SECTION 5

EXTERNAL PARTS

**Bumper**

Front bumper

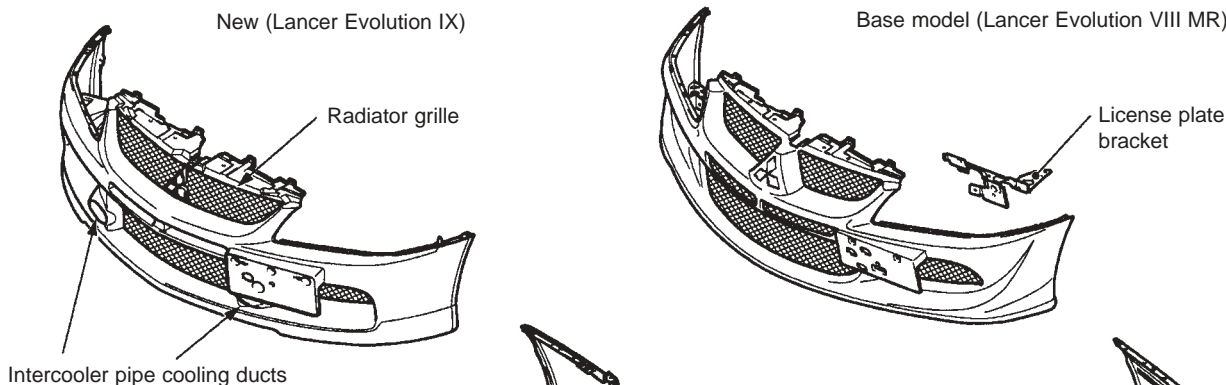
Front and rear bumpers are newly designed; the shapes are now more aggressive and eye-catching.

- Front three diamond symbol is changed
- The radiator grille is now a single grille rather than being split left/right as on the previous model.
- Intercooler pipe cooling ducts have been added to the left and right of the bumper, improving intercooler cooling performance.
- Weight has been reduced by deleting the number plate bracket fixing the number plate garnish.

Rear bumper

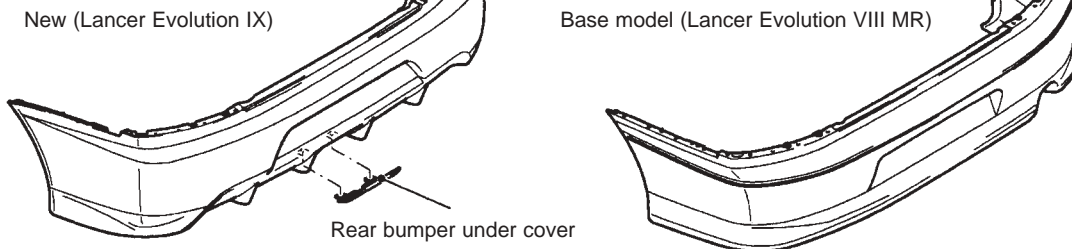
A removable rear bumper under cover has been added to the lower side of the number plate, preventing damage to the bumper when vehicle is towing.

## Rear spoiler

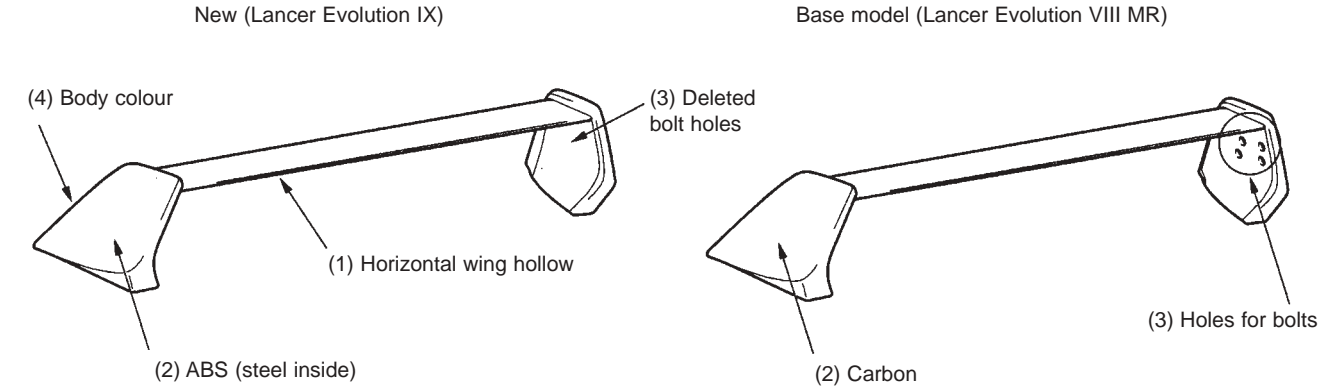
The shape of the rear spoiler has been carried over, but the following changes have been made.

- (1) The horizontal wing is now hollow, making it lighter, and giving the spoiler a lower centre of gravity.
- (2) Material used for the two vertical elements has been changed from carbon to ABS. These struts have also been strengthened by putting steel inside.
- (3) Because of the above changes, we have been able to delete the four bolt holes (on one side) in the vertical struts.
- (4) The vertical struts are now the same colour as the body, distinguishing the vehicle from the previous model.
